CITY OF ALBUQUERQUE

**Planning Department
Transportation Development Services Section**

Re: Certification Submittal for Final Building Certificate of Occupancy for
Atrisco Business Park, Big Lots, [J-10 / D32]
465 Coors Blvd NW
Engineer's Stamp Dated 08/17/05

**Re: Tract F-6-A-1, Atrisco Business Park, Unit 3 – Grading & Drainage Plan
Engineer's Stamp dated 5-3-05 (J10-D32)**

SHEET 2 OF 3

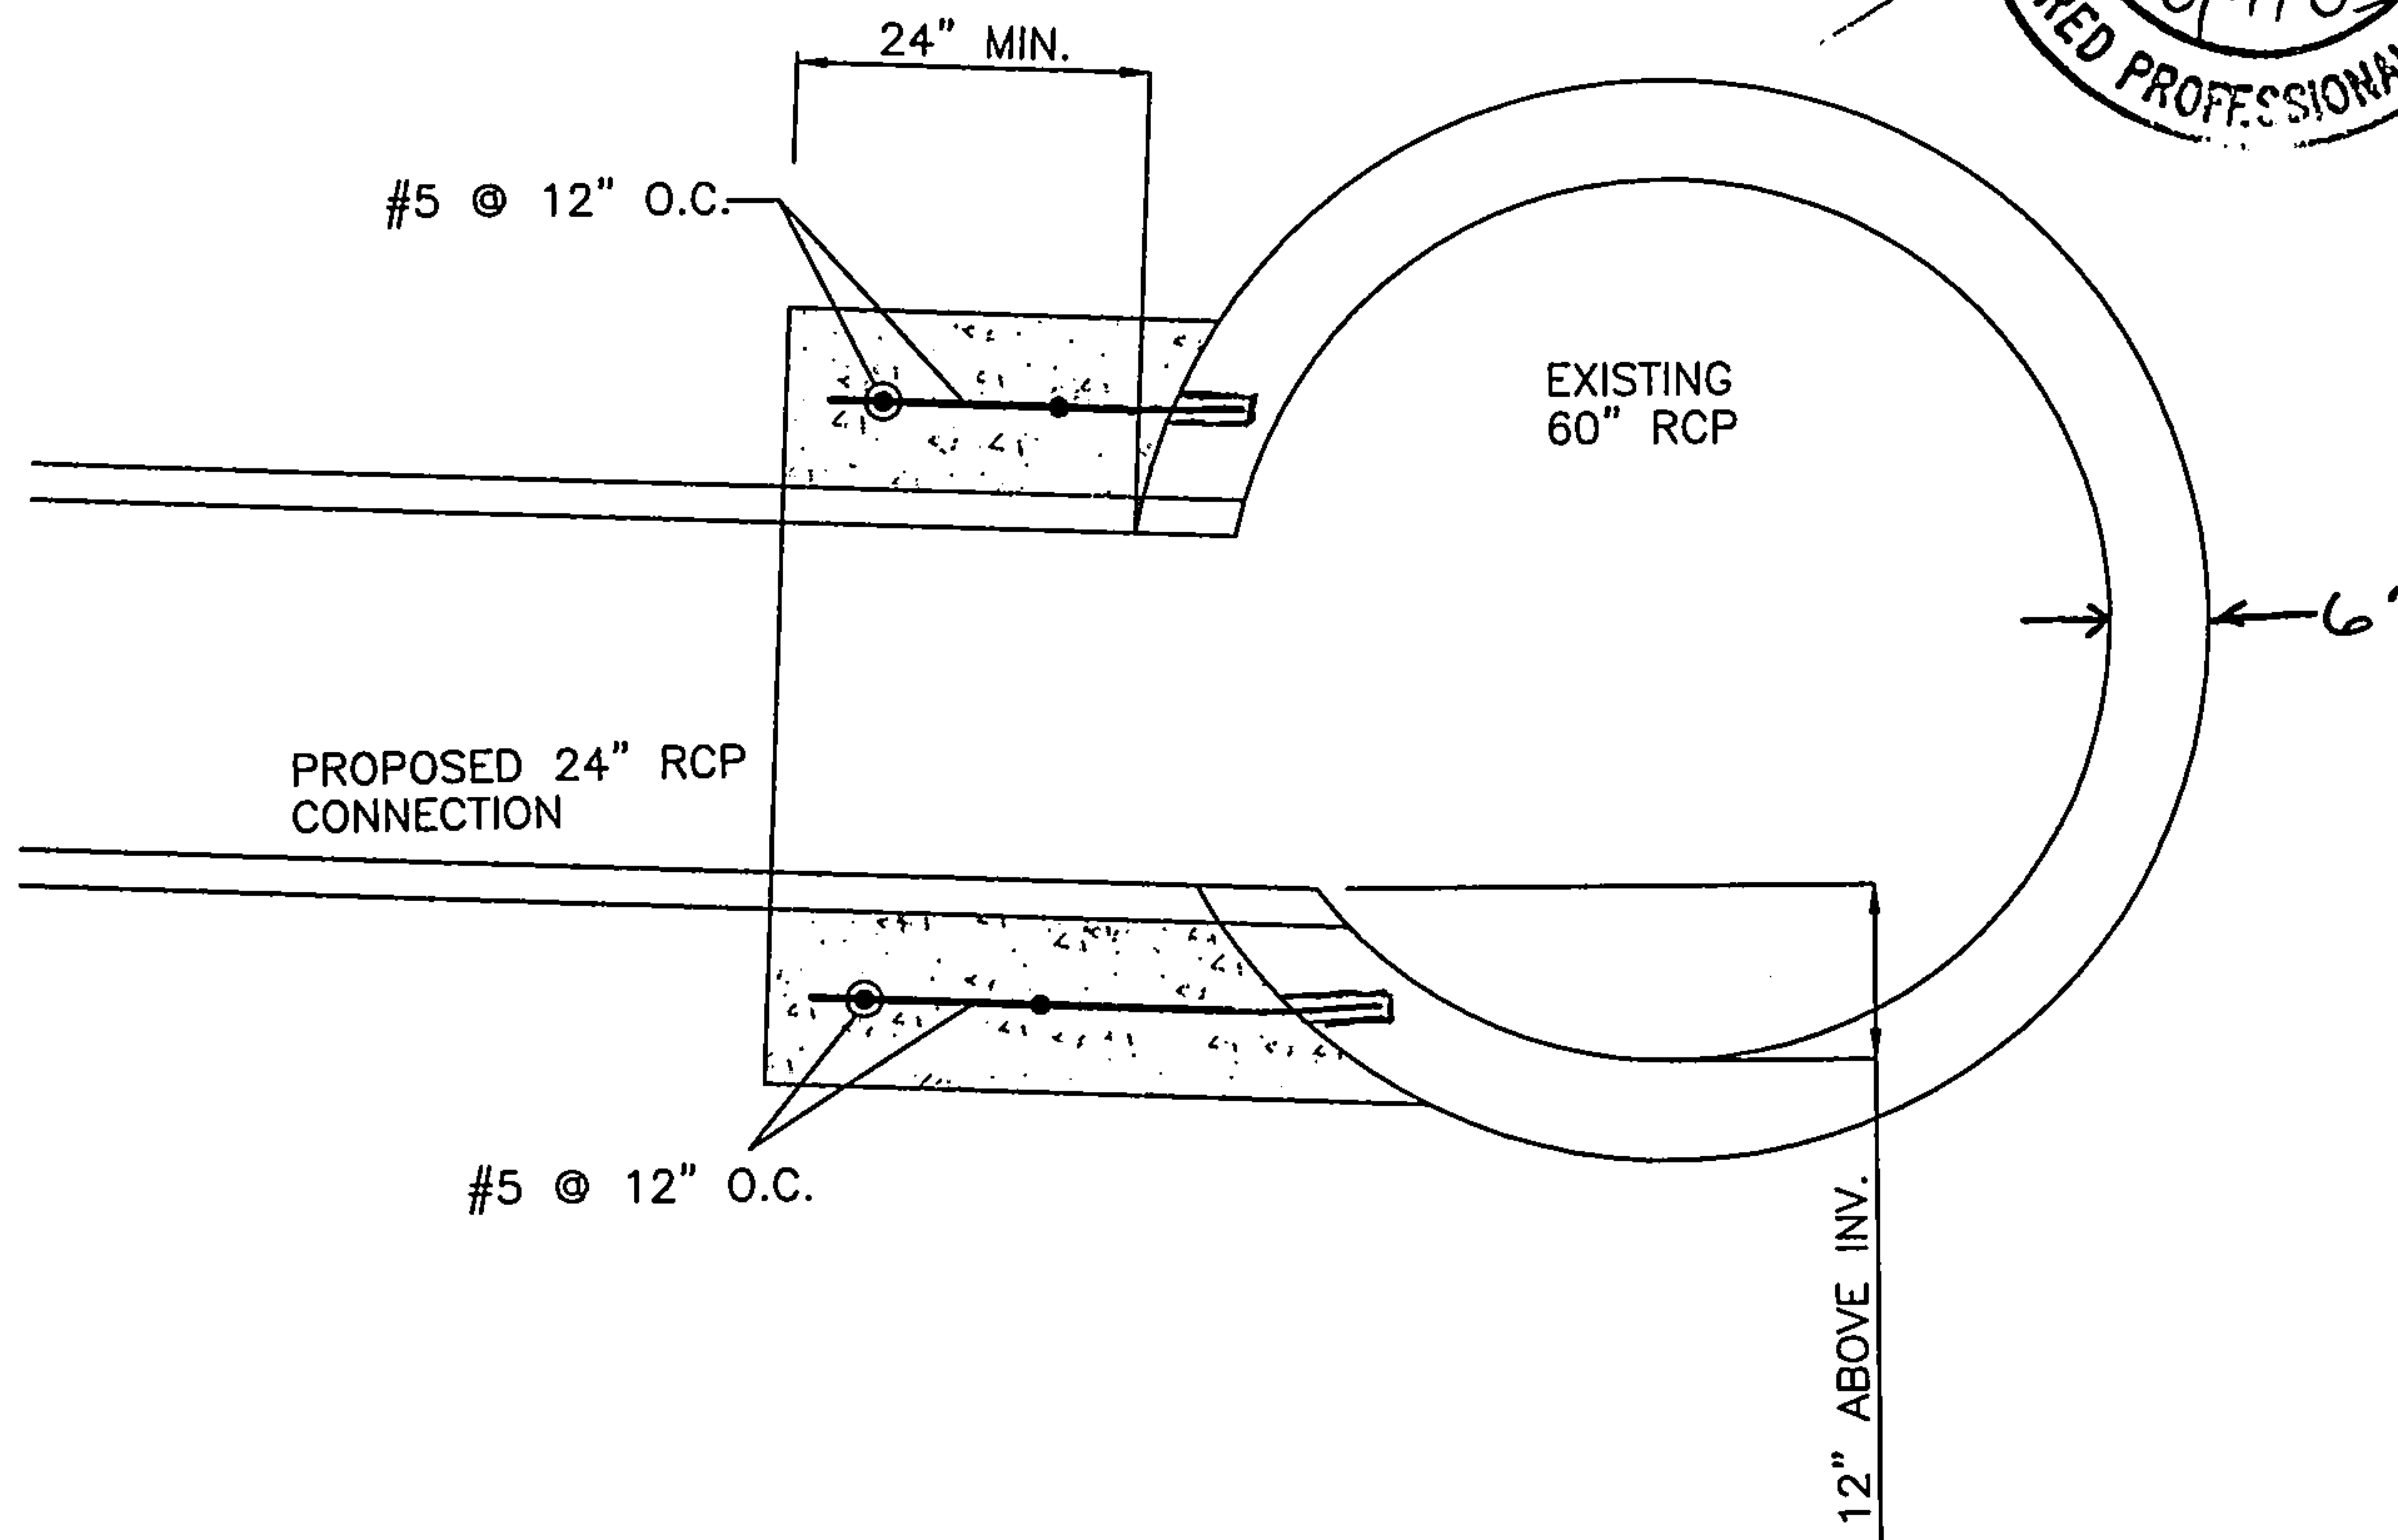
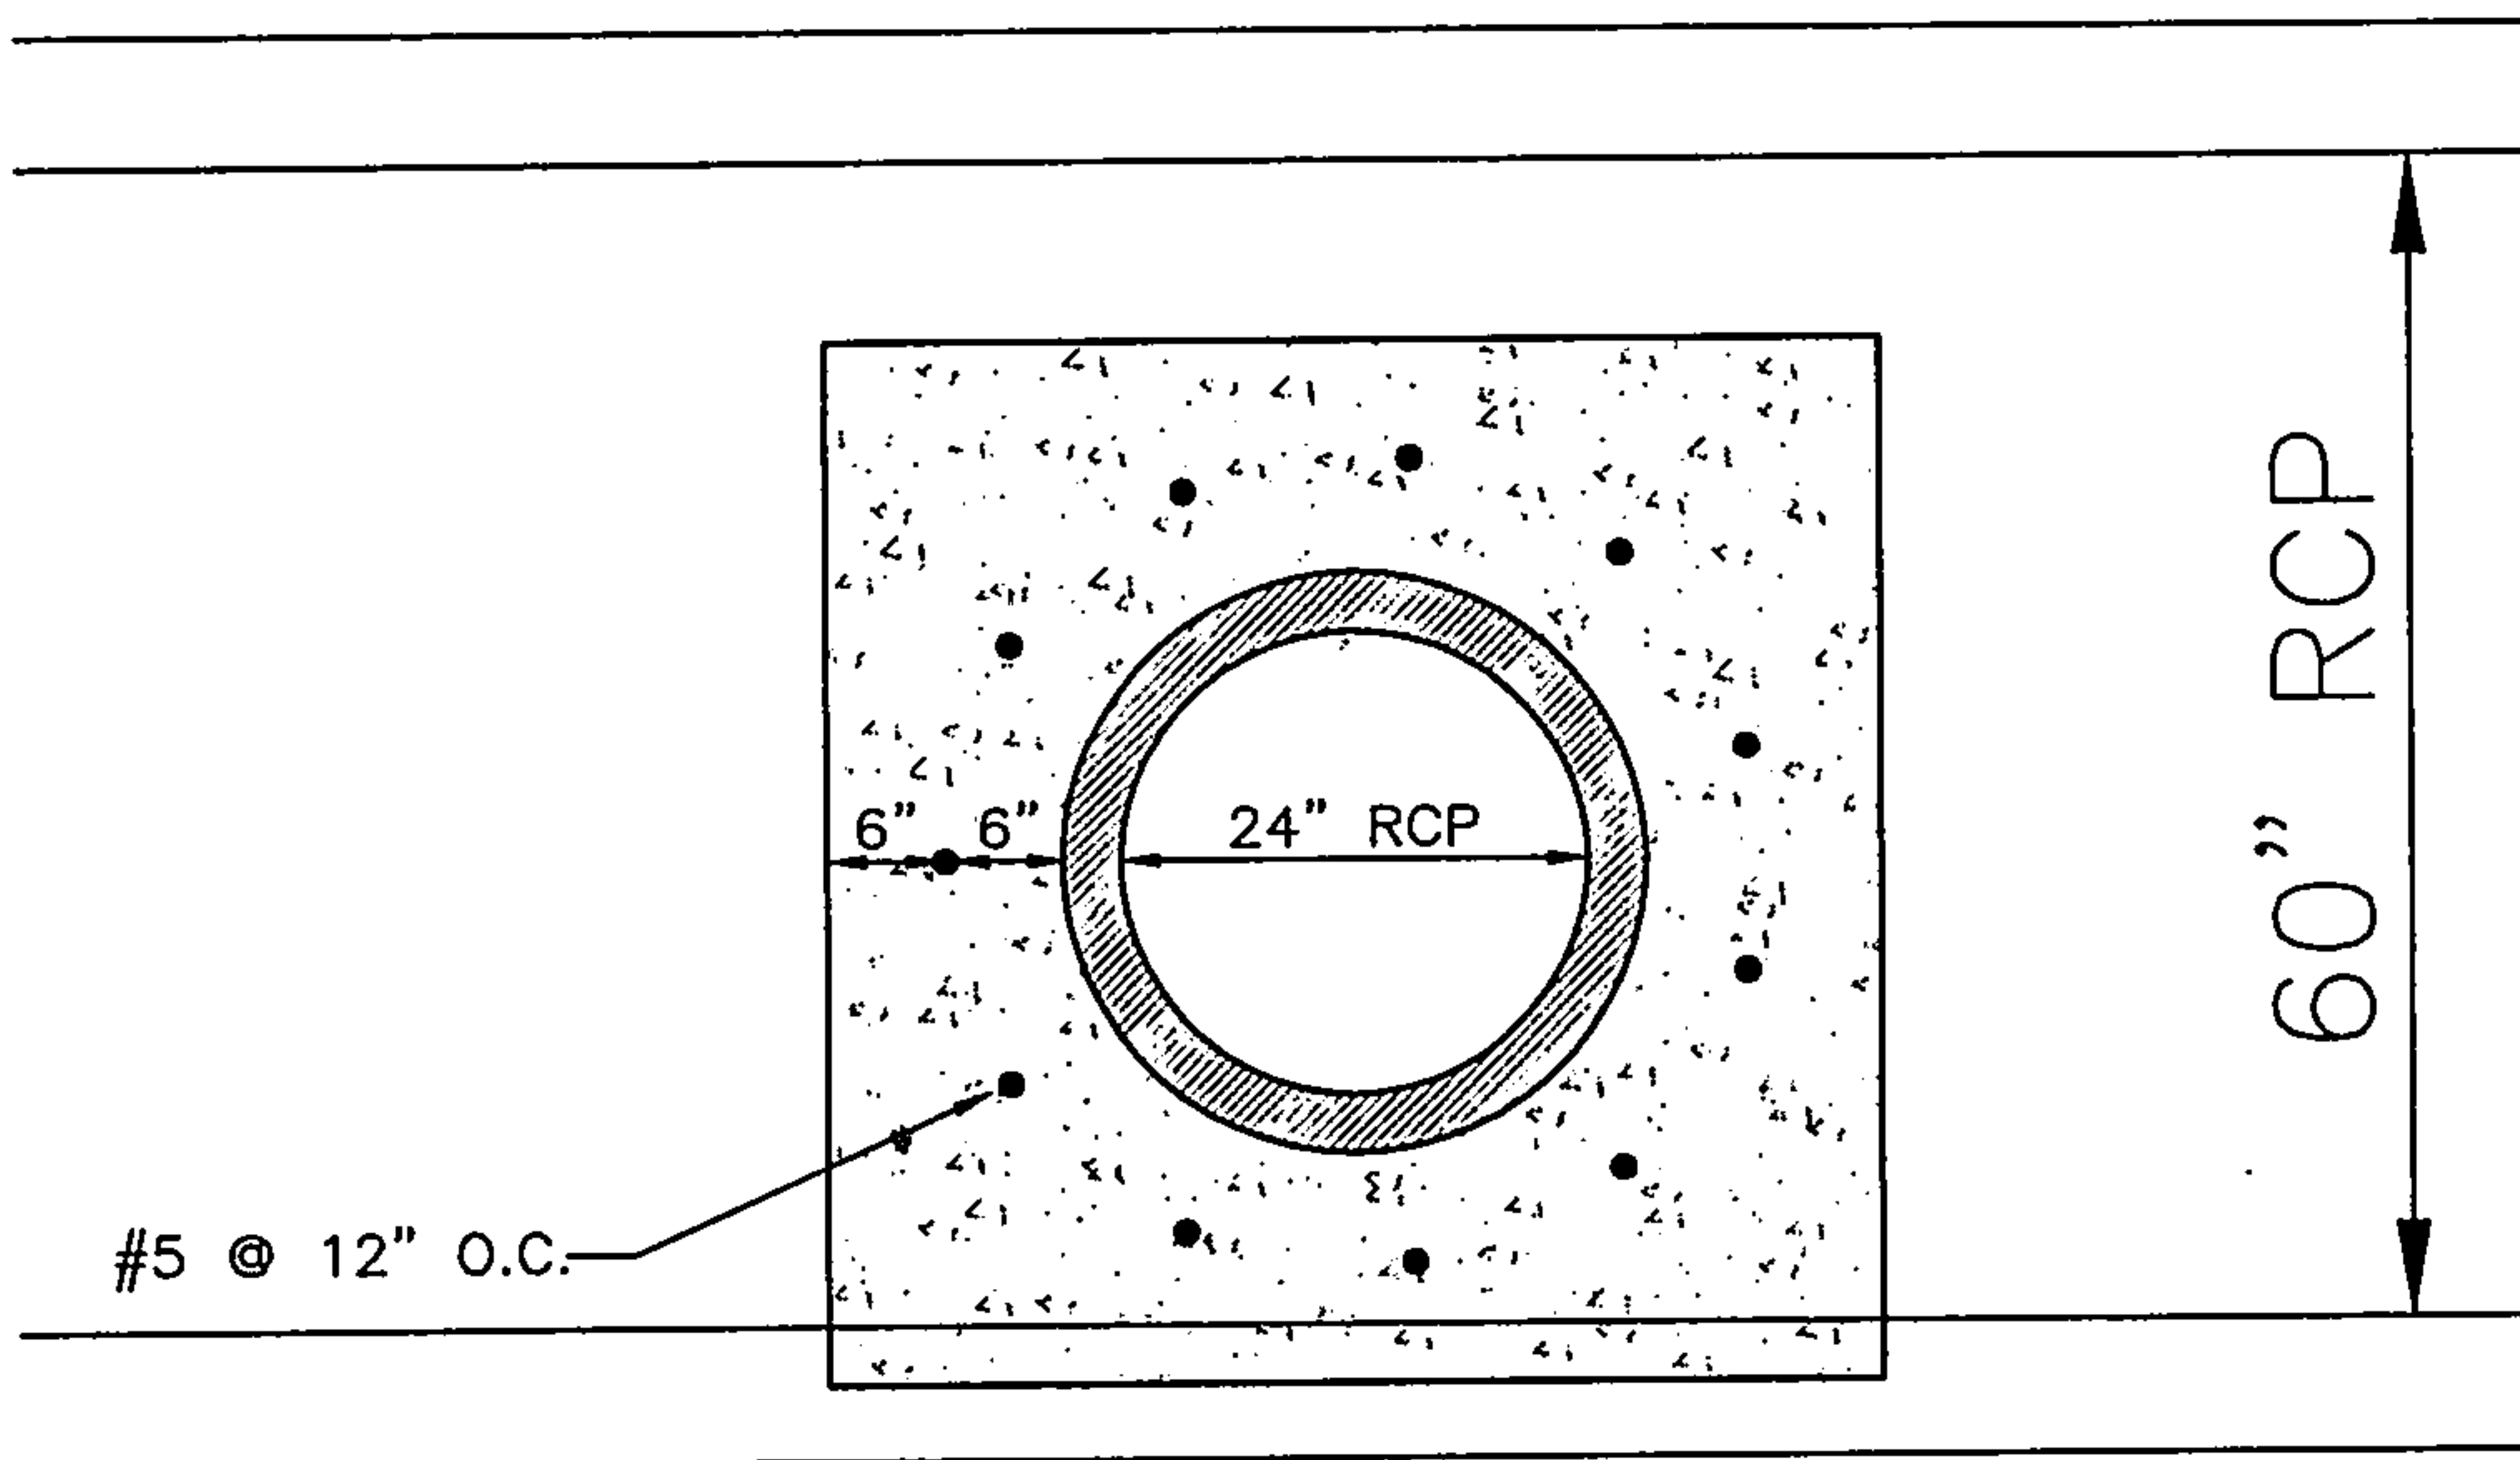
- Show detail for connection to existing storm drain on plan.
- Provide addresses for both sites connecting to existing storm drain.

DETAIL CONNECTION "B"
